Applicant: Lectrosonics, Inc.
581 Laser Road
Rio Rancho, NM 87124

Re: Response to Correspondence reference number 31726

Equipment: FCC ID: DBZUM450V, 731-confirmation number EA623900

Photograph showing separation distance from the back of equipment to the antenna.

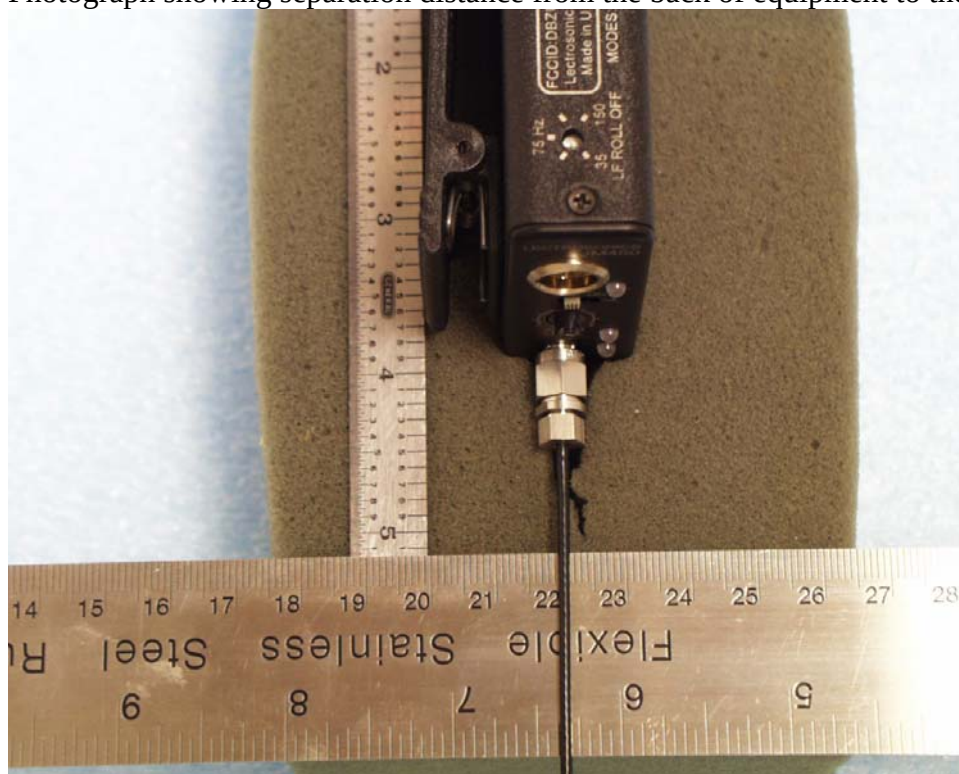
To support FCC RF exposure compliance determination, please submit photos and/or sketches for product with antenna installed showing spacings between the plane of the back of the belt-clip to: a) the back of the device, b) the closest point(s) of installed-antenna(s) FCC will then review all filing info to determine whether other info may need to be requested to support compliance with RF exposure requirements as applicable for all transmitters regulated by FCC. It may help to expedite this review if applicant has available and wishes to voluntarily submit SAR test results for this specific product

Below please find relevant photographs per your request demonstrating spacing between the back of the device and antenna, and the back of the clip and antenna.
